Objection to Proposed Rezoning and By-Law Amendment of 1049 Richmond Ave (REZ-00451)

Originally Submitted: April 23, 2014

Resubmitted for public hearing: July 8, 2015

Figure 1-Proposed lot with existing and proposed variances marked in red³

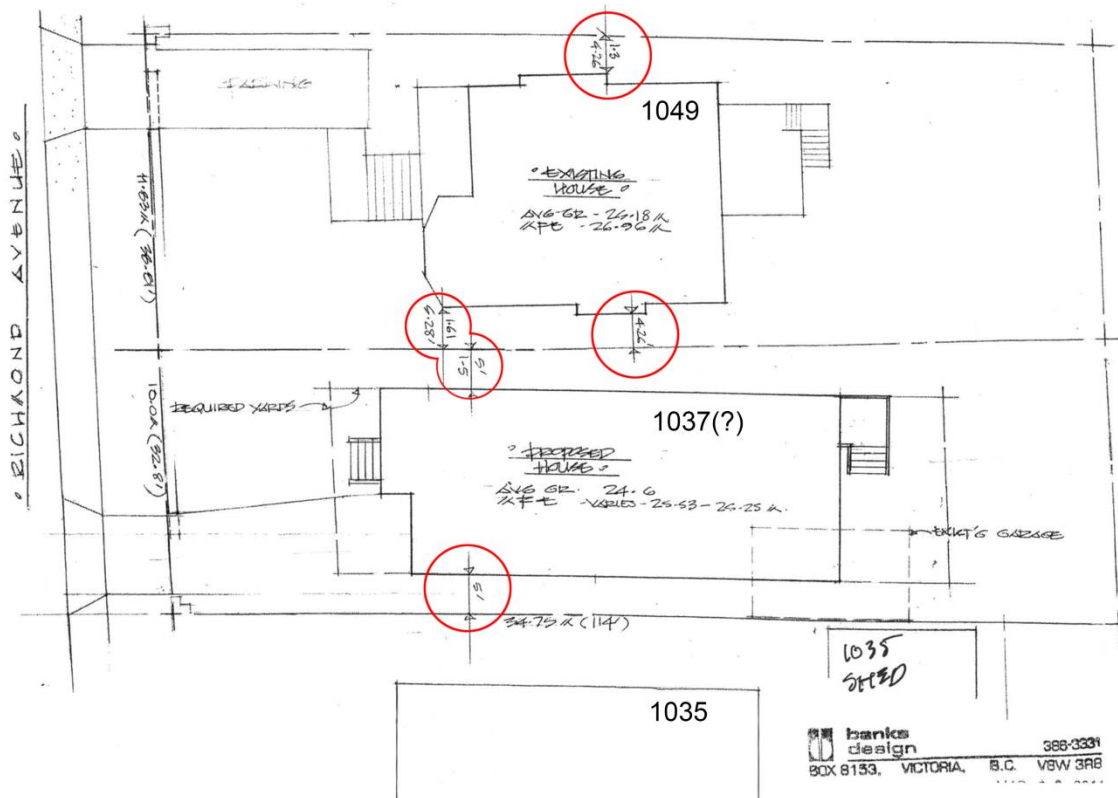
The lot on 1049 is currently zoned as R1-G (single family dwelling-Gonzales district) according to the Victoria Planning & Development Services department. To create the new R1-S2 lots, the proposal relies on a total of almost four meters of setback variances across two lots (See **Figure 1**)

- The existing side setback on 1049 north is already too small. It is apparently 1.3 meters instead of the ~3.15 meters required for a ~21 meter-wide lot according to code R1-G, and less than the 2.4m required for an R1-S2/G2 lot for habitable space with windows.

- The south setback on the newly rezoned 1049 is proposed to be between 1.3 and 1.5 meters instead of the required 2.4 meters for habitable space with windows.

- The north setback on the newly created 1037(?) lot is proposed to be 1.5 meters instead of the required 2.4 meters for habitable space with windows. If granted and combined with the small setback on the south of 1049, this will have an impact on the view, light and privacy received by the purchasers of 1049 which currently has most of its fenestration on the south elevation. The windows of the two houses will now be 2.8 meters away from *each other*, which has obvious implications for privacy, light and fire safety.

- The south setback on the newly created 1037(?) lot is proposed to be 1.5 meters instead of the required 2.4 meters for habitable space with windows. Since the main living space fenestration of 1035 is on the north elevation, the owner and residents of 1035 are opposed to this variance for reasons of privacy, light, view and safety.

Figure 2-Site map with correct side setbacks; 1037(?) site is now too narrow to comply with R1-S2 minimum width. The existing side setback variance at 1049 north remains circled in red. Maximum width of construction at 1037(?) is now 4.6m instead of 7m.

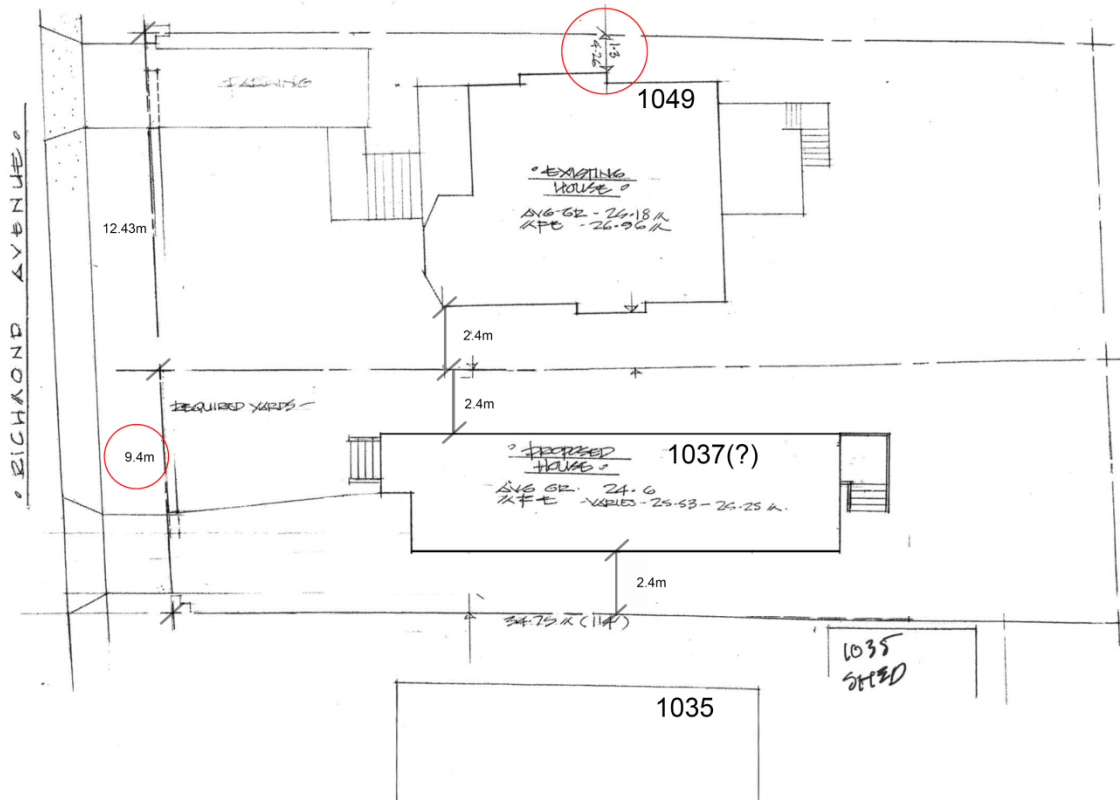
Normally, the rezoning of 1049 and 1037(?) should not occur without the granting of the south setback variance on the existing 1049 building scheduled to become R1-S2, or else the newly created 1037(?) lot would be too narrow (~9 meters) to qualify for the minimum lot width for an R1-S2 zoning (10 meters). See **Figure 2**.

Figure 4-View North-East from 1035 (after proposal)

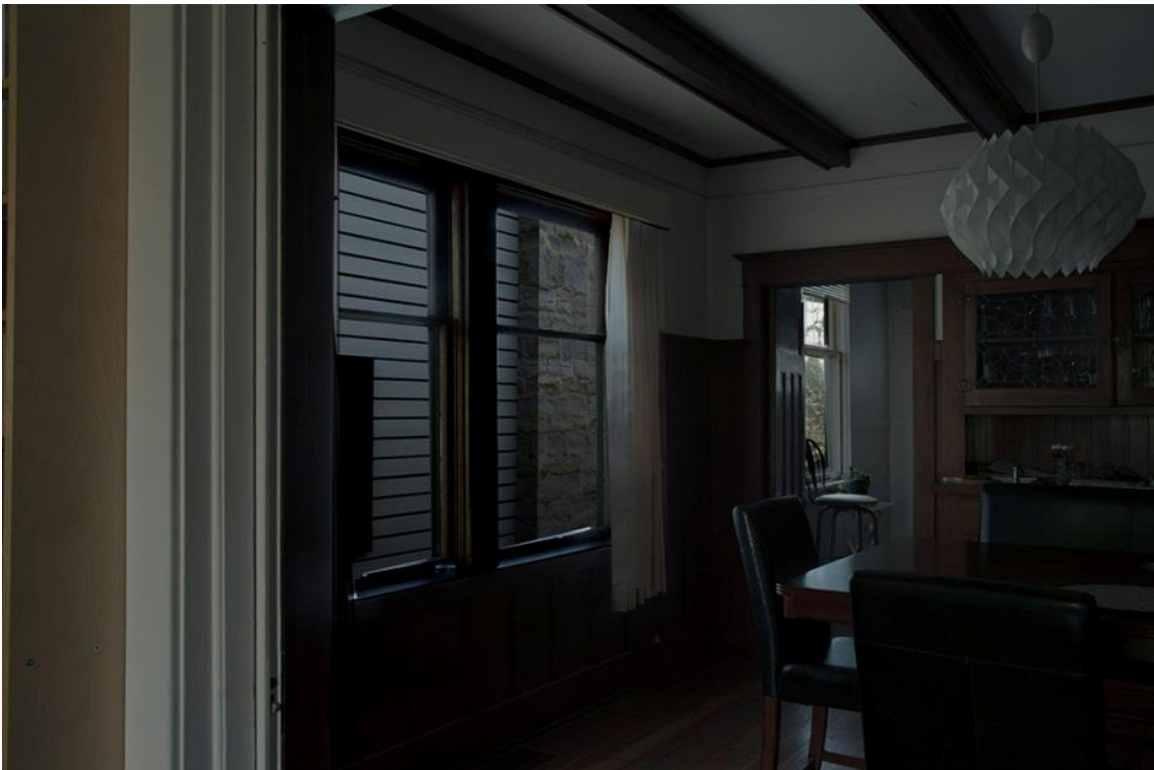
- The proposed construction of 1037(?) is more than 7m tall according to the illustrations provided by Banks Design. While this is allowable for an R1-S2/G2 lot, the requested south side setback variance causes unreasonable view and light obstruction for 1035, which currently receives all of its sky views and natural light from the north side. See **Figure 3** and **Figure 4** (*These images are rendered using the Banks Design measurements and plans provided to us with the Community Petition on April 6, 2014*).

- The requested side setback variances mean that the upper bedroom and den of 1037(?) will end up looking into the living room of 1035 from a short distance, having an impact on privacy.

- The single sloped roof angled away from the 1035 property presents the residents of 1035 with an unreasonably tall elevation. While the official height of the building (midpoint of peak to eaves) is within the limits, the sheer wall facing 1035 is the height of the peak, effectively expanding the height of the building for shading and obstruction purposes.
